Memo

Date: March 10, 2026
To: Holly Ellis, Public Works Director, City of Sandpoint
From: Michael Adamson, PE, RSPi; Fehr & Peers
Subject: Boyer Avenue Cross Section Evaluation

Figure 1. Proposed Cross Section, Boyer Avenue between Baldy Mountain Road and Mountain View Drive

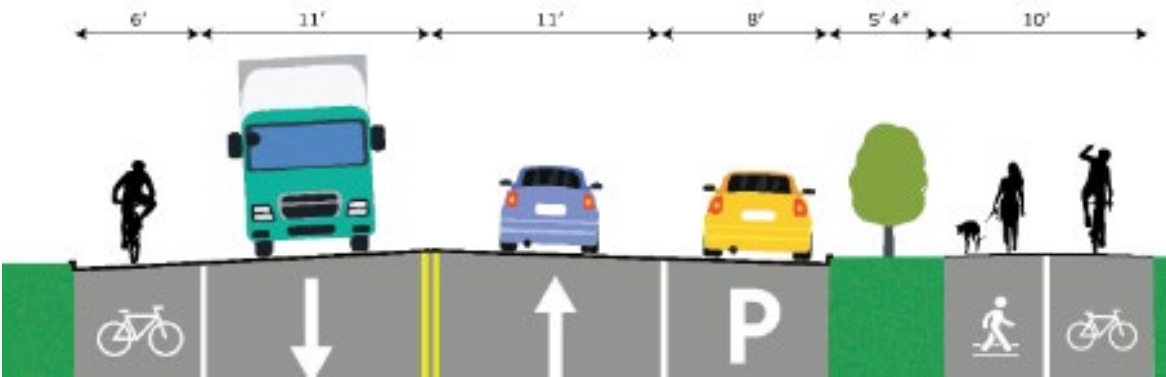
As part of these updates, the dedicated southbound bicycle lane would remain in place, while the speed limit would be reduced from 35 miles per hour (mph) to 25 mph. It should also be noted that, although the figure shows the pedestrian path on the east side of the road as having a 10-foot width, existing conditions show an 8-foot width except at intersections. Recognizing the City's hope that this proposed project would not require any more paving, the width of the path within the proposed cross section was considered to be 8 feet, consistent with existing conditions.

1. Introducing on-street parking along a freight corridor can increase side friction and reduce the effective operating width for trucks. Large trucks may encroach into adjacent lanes when passing parked vehicles, potentially affecting operations, comfort and safety for other road users.²

2. A striped bicycle lane is not typically recommended on a freight-oriented corridor, for similar reasons of side friction as well as comfort and safety. Instead, it is generally recommended that vertically separated or at least buffered facilities be prioritized if bicycle traffic is being prioritized alongside freight traffic.³

- a. Given the existing path is only 8 feet in width and thus does not meet design requirements to allow for bi-directional mixed pedestrian and bicycle travel, **the current cross section of Boyer Avenue would not allow for this without additional paving and/or reconstruction of the curb to bring the width to at least 10 feet, although 12 feet would be recommendable where possible.**

3. The reduced speed limit (35 mph to 25 mph) is not in keeping with MTMP’s defined purpose for the gateway corridor of moving goods quickly to/from/through the City to the larger regional network. Although this reduction can be done, it is atypical of arterials with a high freight priority.

Restriping Boyer Avenue to add on-street parking on the east side between Baldy Mountain Road and Mountain View Drive (including reducing the speed limit) is not recommended. The corridor serves an important freight function, and adding parking and reducing the lane widths while maintaining the striped bicycle lane could reduce operational efficiency and increase conflicts between trucks, cyclists, and parked vehicles. Additionally, the cross sectional improvements would only be feasible for a limited section of the corridor, and would be inconsistent with development patterns recently approved further north along the corridor.

- Allow the proposed development to orient away from Boyer Avenue, using landscape buffering along the roadway rather than a formalized parking area. This is consistent with the development pattern that has already occurred along Boyer Avenue within and around the study segment.
- Preserve the corridor for freight movement, at least until the Baldy Mountain Road Extension is completed and corridor needs can be reevaluated (consistent with recommendations in the MTMP).
- Program in expansion of the shared-use path on the east side, including potentially removing the southbound bike lane, to create a wider vertically separated facility for pedestrians and cyclists.
